Appeal No: ACP -323120-25

Applicant's response to appeals

RE: RESPONSE TO THIRD PARTY APPEAL IN RESPECT DEMOLITION OF BUILDINGS/STRUCTURES AND CONSTRUCTION OF A 14 STOREY BUILDING INCLUDING OFFICE USE, ARTS CENTRE AND CAFÉ, AUDITORIUM, AND ANCILLARY USES AT SITE BOUND BY CITY QUAY TO THE NORTH, MOSS STREET TO THE WEST & GLOUCESTER STREET SOUTH TO THE SOUTH, DUBLIN 2. THE SITE INCLUDES 1-4 CITY QUAY (D02 PC03), 5 CITY QUAY AND 23-25 MOSS STREET (D02 F854).

Figure 4.3: Extract from HJL's FI Appeal Response showing eastern elevation.

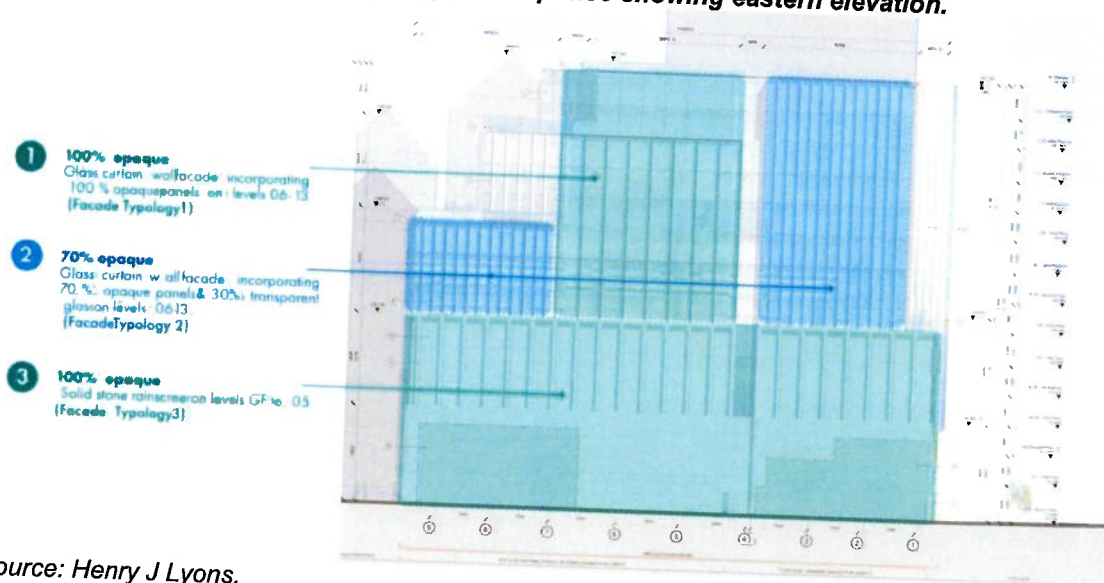
The City Quay National School has raised concerns regarding the impacts on the future development potential of their site as a result of the proposed development at 1-6 City Quay.

However, at further information stage the eastern elevation of the proposed development was revised to address concerns raised by DCC regarding the development potential of the adjacent lands to the east of the site. In response to these concerns, the fenestration of the eastern elevation up from the third to fifth floor levels was omitted and replaced with solid stone rainscreen. This will allow for future development on the lands to the east to abut the proposed development up to fifth floor level. See below extract from HJL's appeal response document which is submitted as part of this appeal response

An Taise Appeal Letter - 24th July 2025

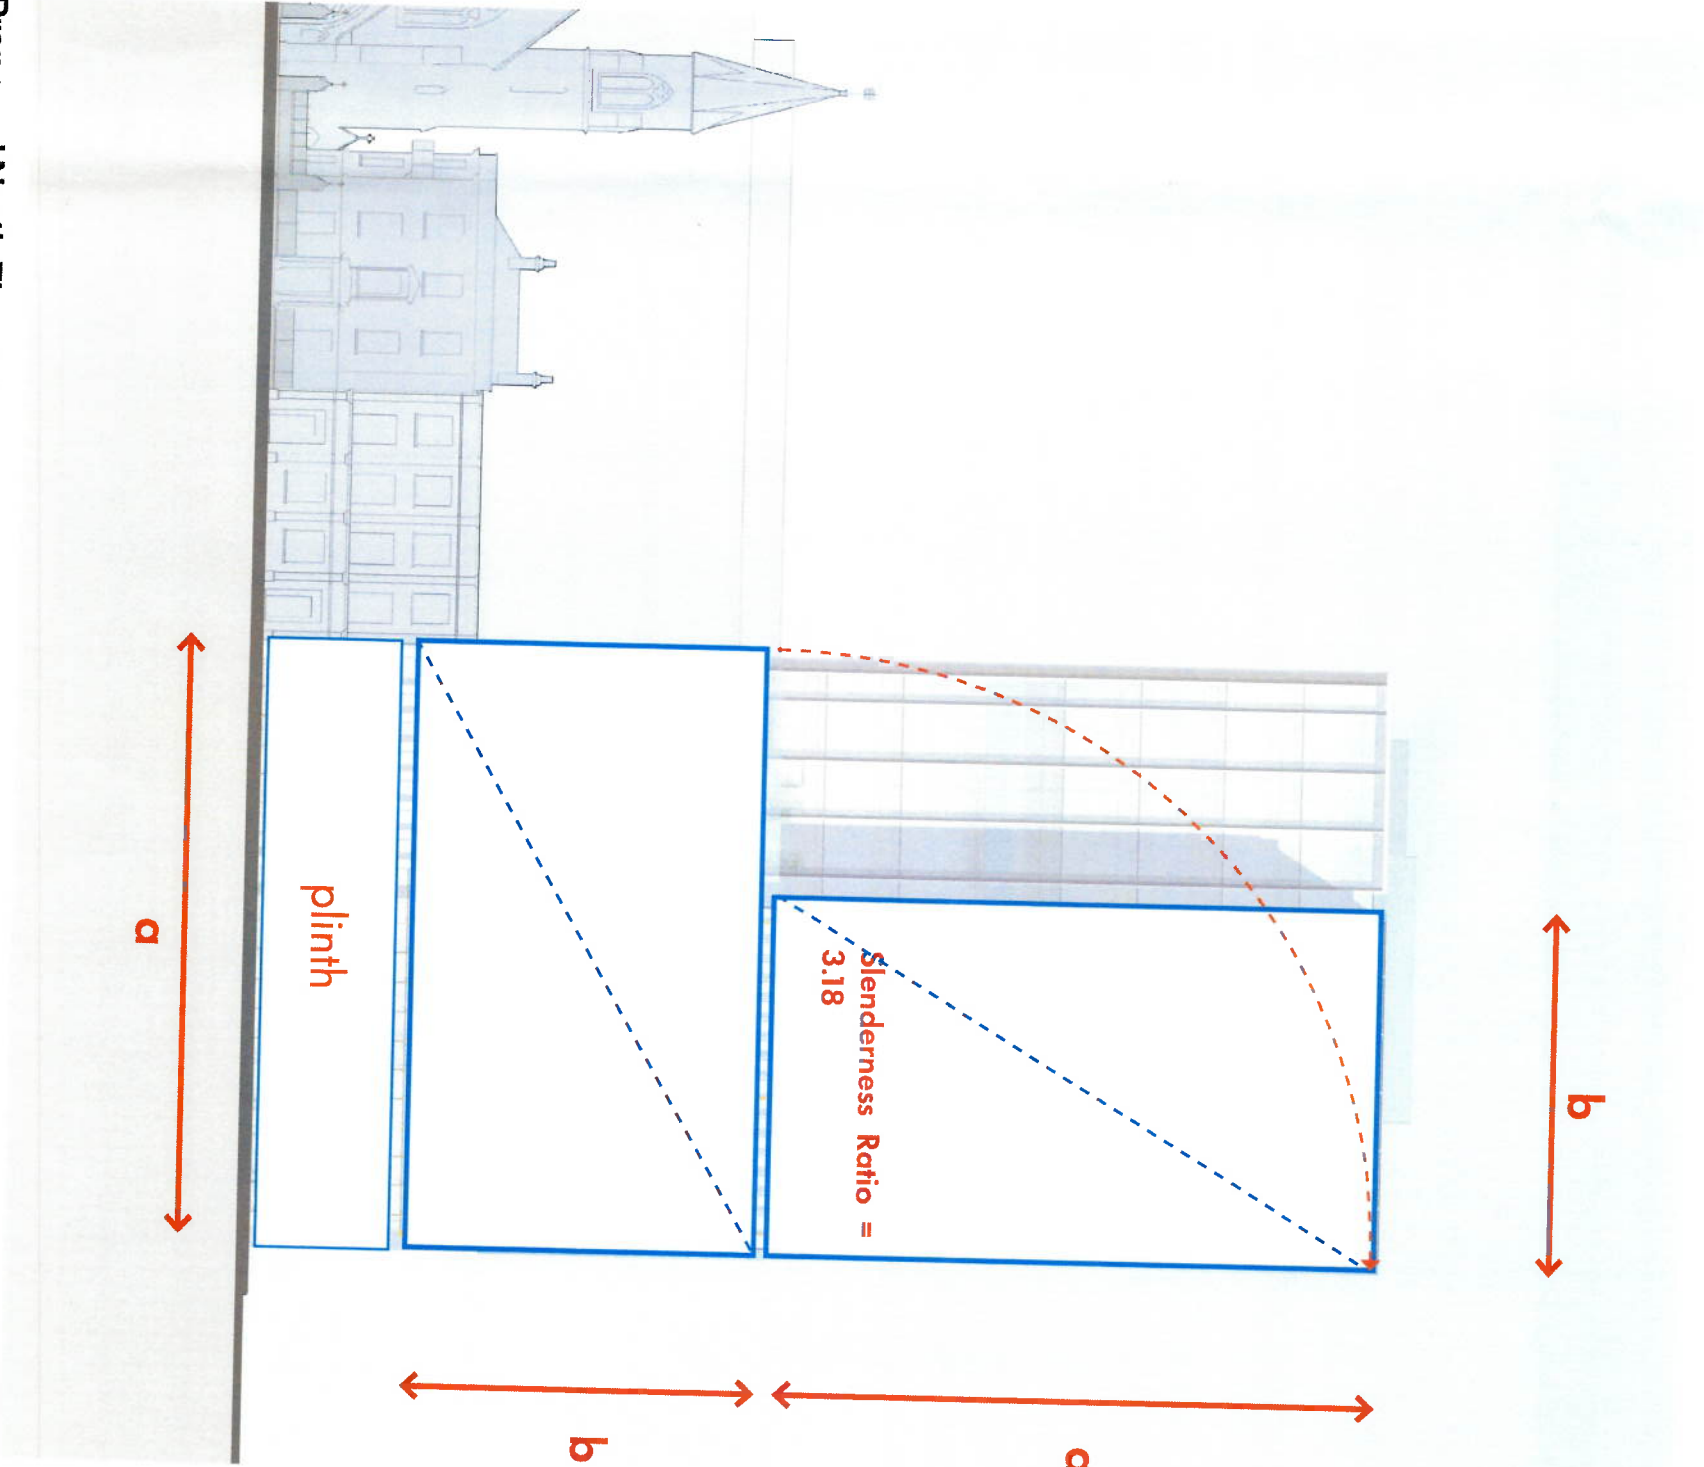
"It is considered that the scale and architectural composition of the proposed building would need to be thoroughly revised using a lower plot ratio and site coverage. The aim should be to form a more elegant and harmonious arrangement of parts within the given space, avoiding the heavy-set 'monolithic block' form of the proposal as existing, and avoiding overbearance on the adjoining National School, protected Presbytery and City Quay Church."

"The design of the proposed building itself is bulky and repetitive, with a speculative appearance, having a curtain-wall bearance, blocking out light to an entire city block. Viewing the drawings and CGI images submitted with the application, it is considered that the proposal lacks coherent architectural expression, appearing jumbled and consisting of too many parts and elements, in particular when seen from the front and east. The problem appears to be that the basic silhouette or profile of the building is excessively "massed and monolithic and does not lend itself to successful break-down."

Applicant Response

City Quay National School Appeal - 23rd July 2025

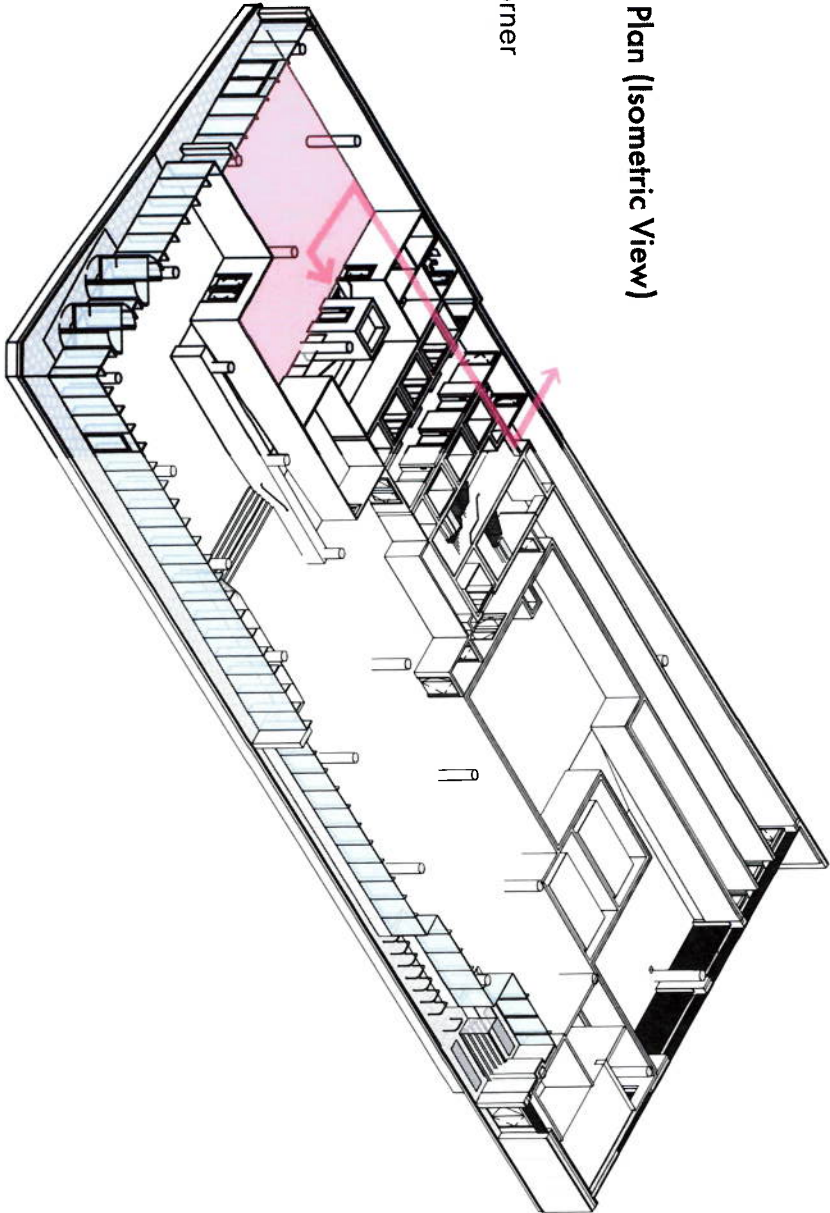
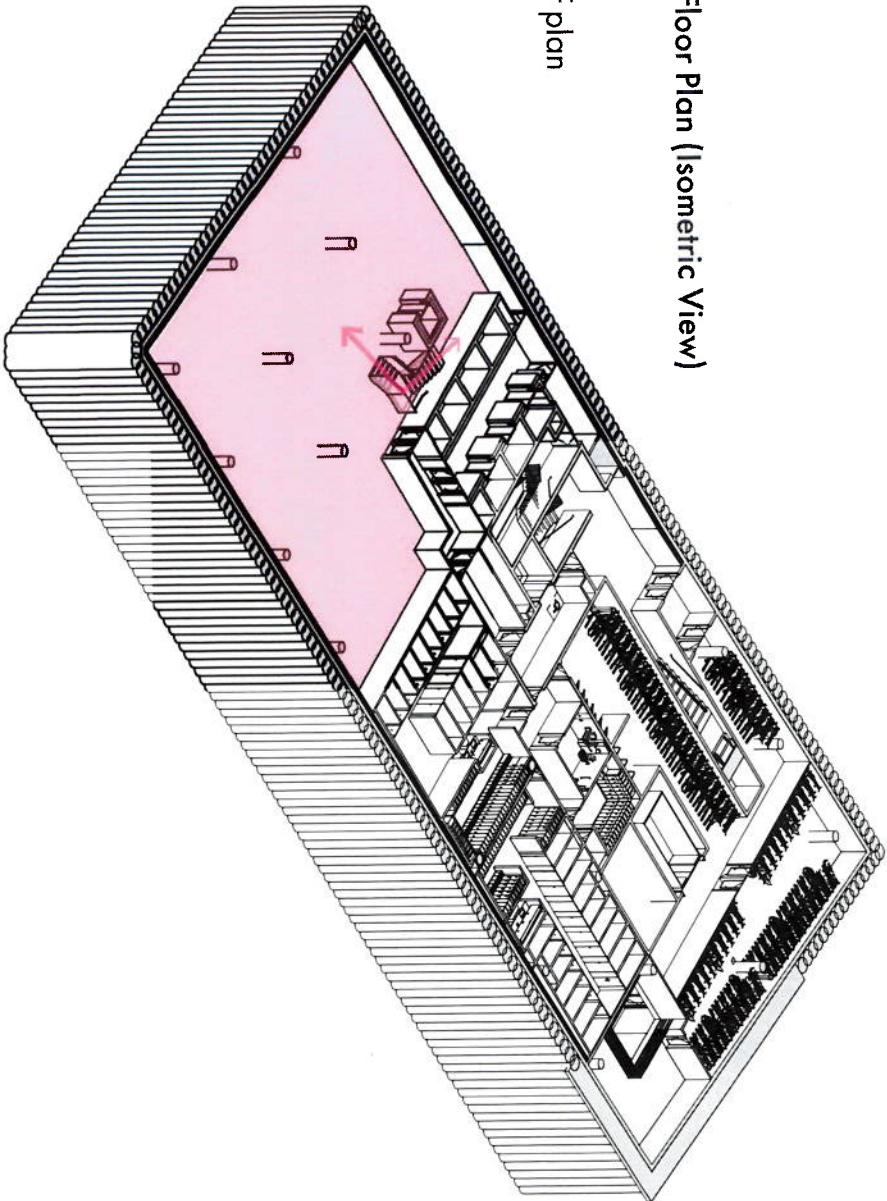
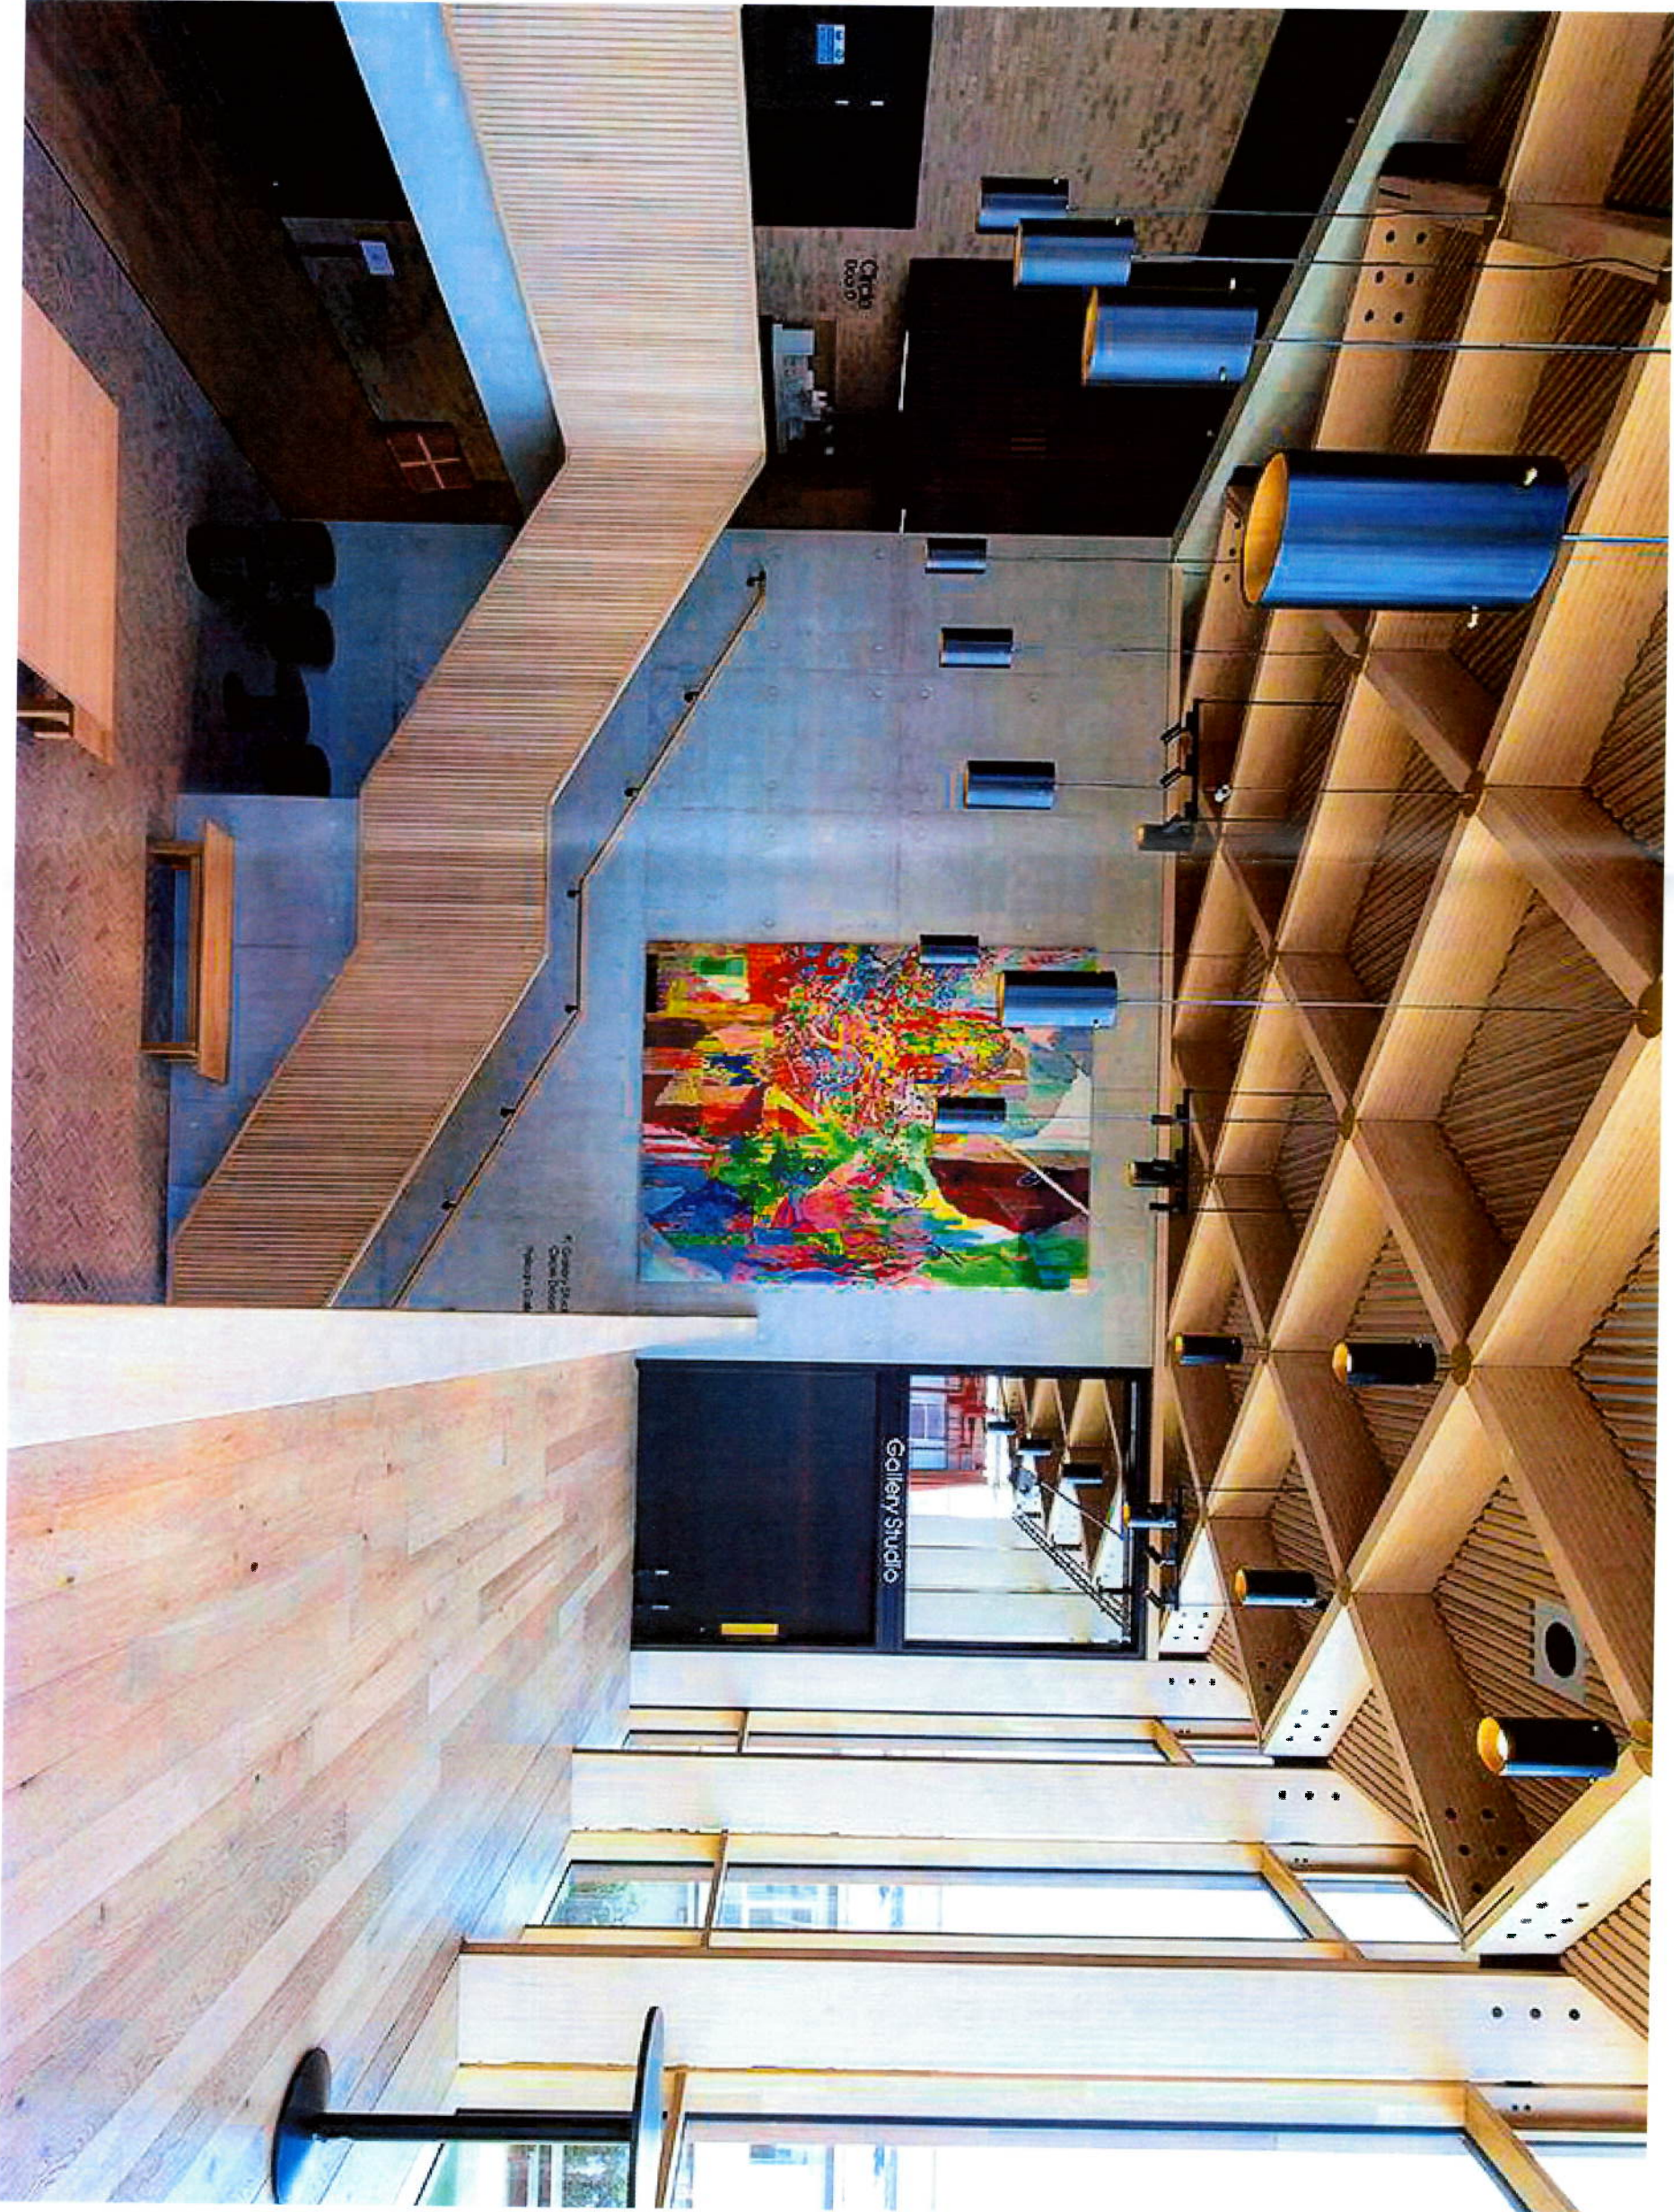
“The development provides no planning gain for the local community”

The applicant submits that 5% of the building use is designated as ‘Community, Arts and Cultural Space’ and that the applicant has offered for this space to be usable by City Quay School.

Figure 2.1: 'Existing Situation' March 21st, 3pm as represented in the Solearth report (R). Areas indicating flawed model in the same image (L).

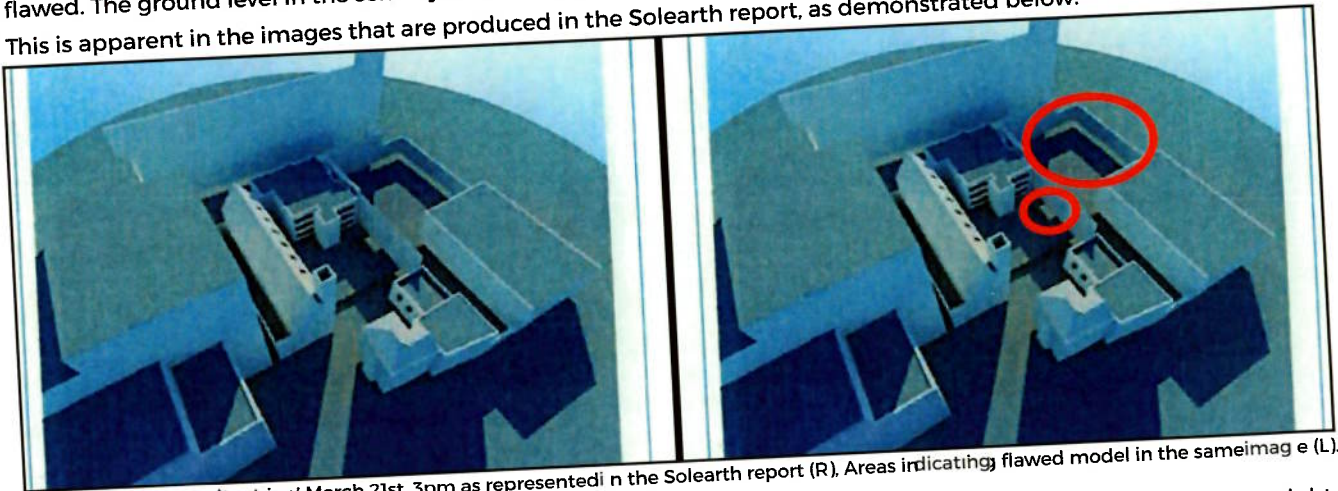
Figure 2.1 above (left) shows the rendering produced for the 'Existing Situation' at 3pm on March 21st. On the right, this image has been repeated with red circles indicating sunlight being cast under the boundary walls. This occurrence is prevalent in many other renders within the Solearth report.

There are two likely modelling errors that would lead to this happening. Either the base of these boundary walls is incorrect (not meeting the ground plane), or the level of the plane receiving shadows is too low. Careful inspection of these images indicates that the ground plane in the Solearth overshadowing renders is too low. This is evident in a comparison between the Solearth renderings for 12 noon on March 21st and the 3DDB renderings of the same time, as shown in Figure 2.2 below.

Figure 2.2: 'Existing Situation' March 21st, 12pm as shown in the Solearth report (R). March 21st rendering taken from the 3DDB assessment model (L).

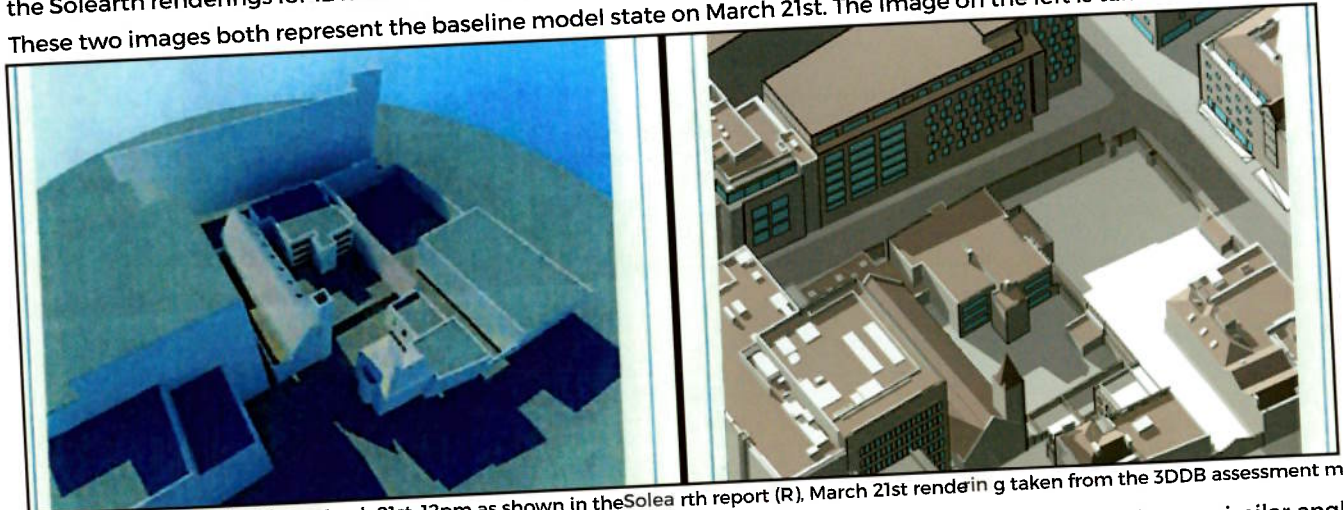
report, and the image on the right has been generated from the 3D Design Bureau model, taken from a similar angle as the Solearth rendering for ease of comparison.

It has been verified in the 3DDB model that the schoolyard has been represented at approximately the correct level (+/- 250mm). In a comparison of the baseline models, the shadows cast by the school building into its own yard inevitably extend further in the Solearth rendering than they do in the 3DDB rendering. There is also further evidence of sun shining under buildings in the Solearth rendering as can be seen under the church and along the northern boundary in the rendering above.
